PREVOST

SAFETY RECALL

Sr05-14A

DATE : November 2005	SECTION : 06
SUBJECT : NEW MULTIPLEX SOFTWARE PROGRAM AND INSTALLATION OF NEW WIPER HARNESS

FIGURE 1: CABLE ROUTING

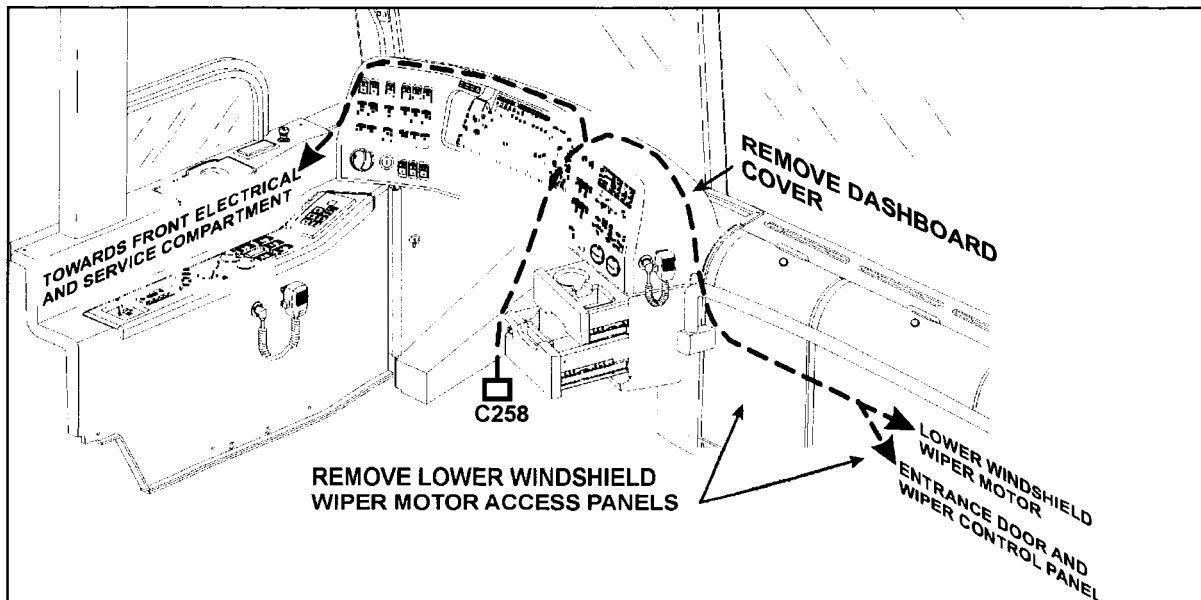
1. Remove dashboard cover and lower windshield wiper motor access panels (Refer to figure 1).

2. Disconnect connector C258 located at the base of steering column. Connect connector C258 of the new harness (066734) with cable coming from steering column multifunction lever.
3. Route cable end labeled "wipers" through inside of the dashboard and behind the driver's HVAC unit, towards the lower windshield wiper motor and the entrance door and wiper control panel; route the other end towards the front electrical and service compartment. Make sure the harness is properly secured using nylon ties by following the necessary precautions (Refer to figure 1).

FIGURE 2: FRONT ELECTRICAL AND SERVICE COMPARTMENT

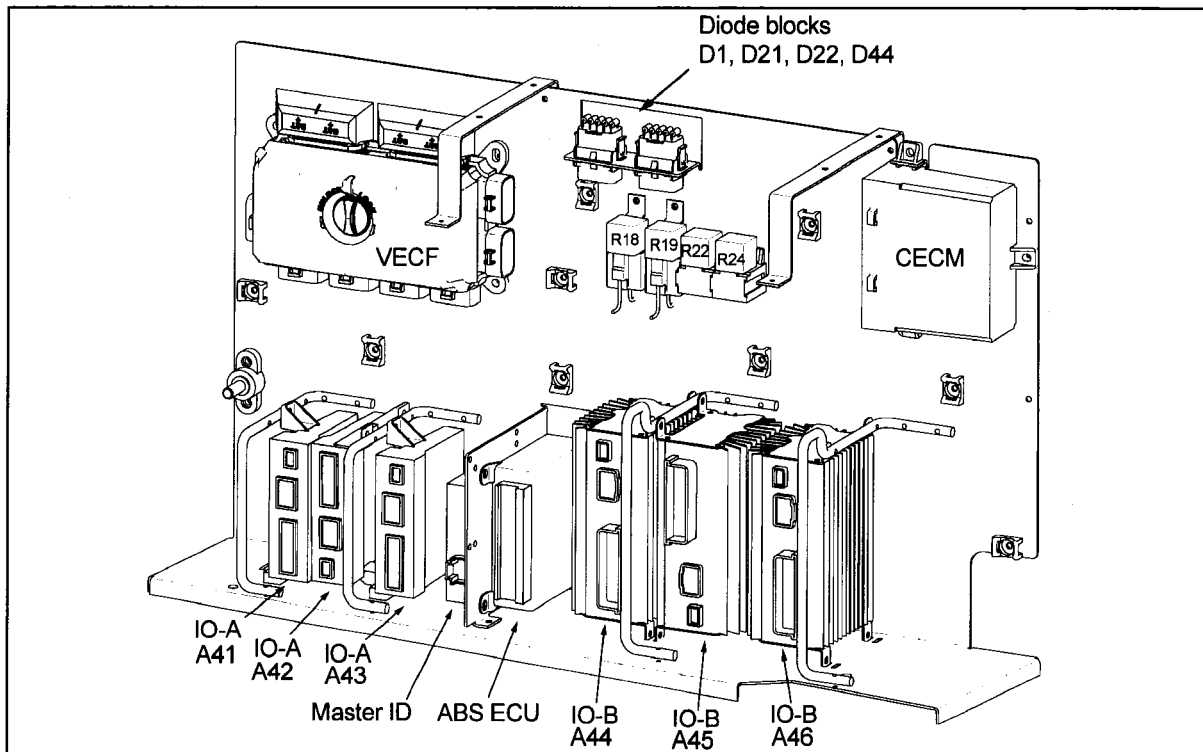
- Cut heat shrink tubing up (561918) into five 2.5-inch long pieces;
- Inside front electrical and service compartment, solder wire 24V17 of the new harness with wire 24V17 of RED connector VECF2-F; cover solder with heat shrink tubing;

- Connect wire 64A of the new harness into connector J1, socket number 5 of module A43;
- Remove wire 64A from connector J1, socket number 20 of module A43 then cover wire end with heat shrink tubing;

- Remove wire 59 from connector J1, socket number 8 of module A43 and cover wire end with heat shrink tubing, connect wire 59 of the new harness into connector J1, socket number 8 of module A43;
- Connect wire 53D of the new harness into connector J1, socket number 9 of module A44;
- Remove wire 53D from connector J1, socket number 9 of module A46 and cover wire end with heat shrink tubing;

- Connect wire 53C of the new harness into connector J1, socket number 4 of module A42. It is possible that wire 92 be already inserted into this socket, if this is the case; connect wire 92 into connector J1, socket number 2 of module A42 before inserting wire 53C in place;
- Remove wire 53C from connector J1, socket number 8 of module A42 then cover wire end with heat shrink tubing.

FIGURE 3: ENTRANCE DOOR AND WIPER CONTROL PANEL

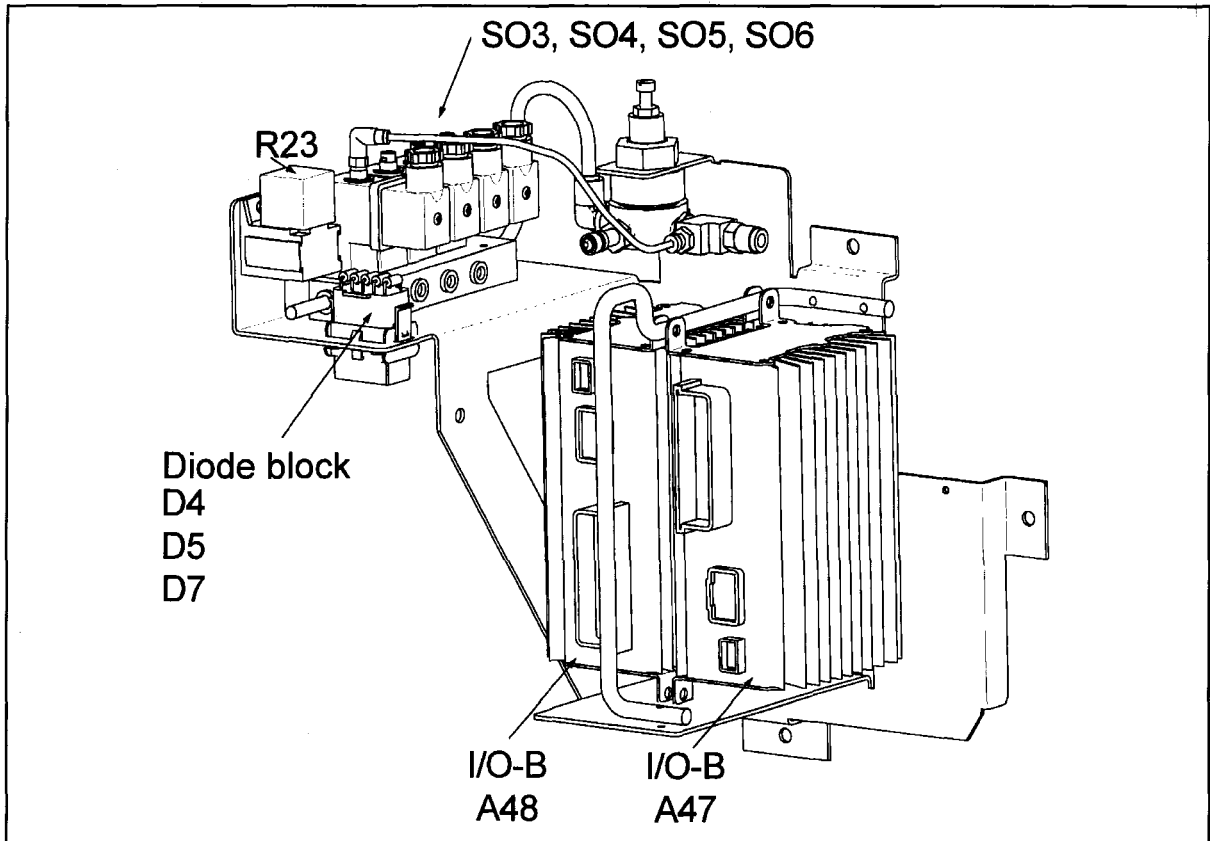
- Remove wire 53B from connector J1, socket number 4 of module A47 and insert into butt splice (562935); insert wire 53B of the new harness into the other end of the butt splice, crimp and heat both ends.
- Remove wire 53G from socket number 30 of relay R23, and insert into butt splice (562935); insert wire 53 of the new harness into the other end of the butt splice, crimp and heat both ends.
- Insert wire 31B of the new harness into socket number 30 of relay R23.
